HWY. No. 622

LOCATION ATIKOKAN RIVER

BRIDGE REPAIRS

Atikokan River Bridge; Hwy. #622;  
Site 45-112; District #19-Thunder Bay.

TYPICAL LONGIT. SECT'N.  
OF  
PROPOSED NORTH SPAN  
ATIKOKAN R. BR.  
HWY. 622 SITE: 45E112

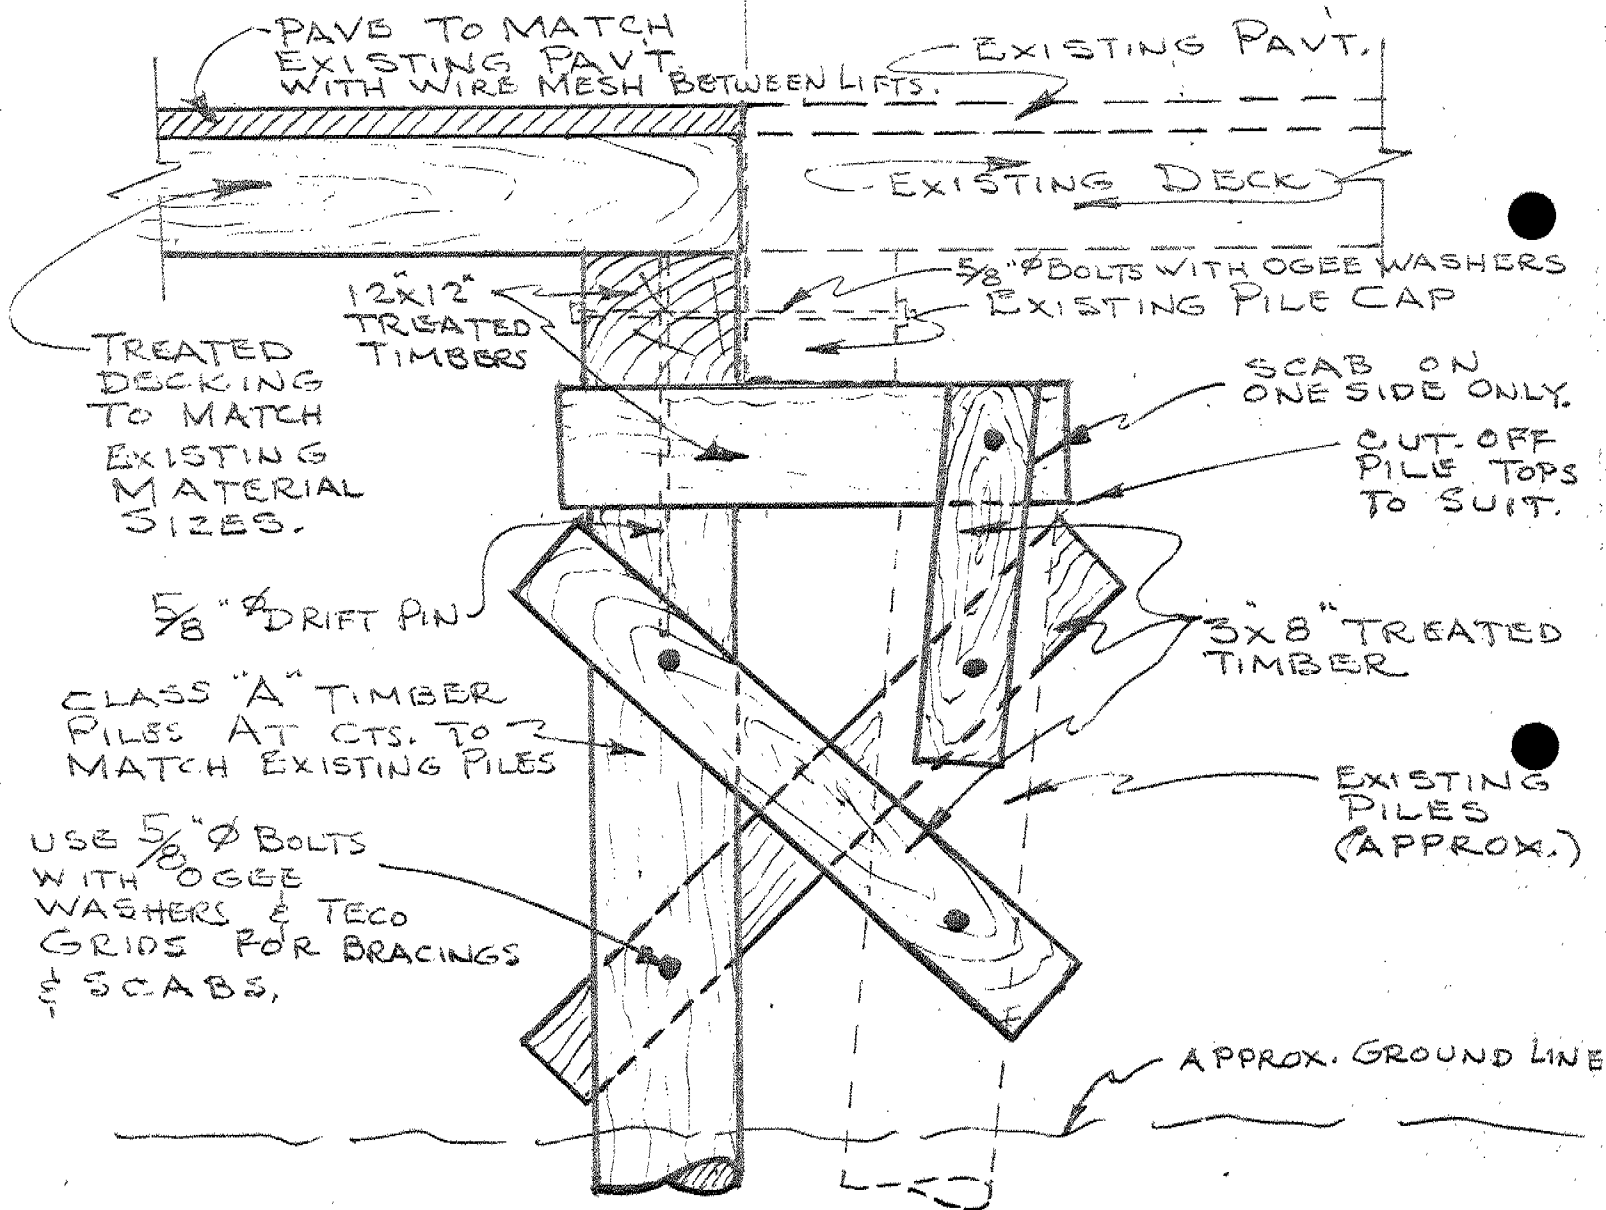
In order to increase the length of the extra span proposed in your memo of January 4<sup>th</sup>, it is suggested that the extra span consist of 2" x 12" laminations with a timber plank deck and asphalt surface. The span could then be lengthened to 18'.

The deck size would not then match with the existing but this could be accommodated by adding to the size of the existing bearing beam. The slope in front of the rock-filled timber crib would then be flatter.
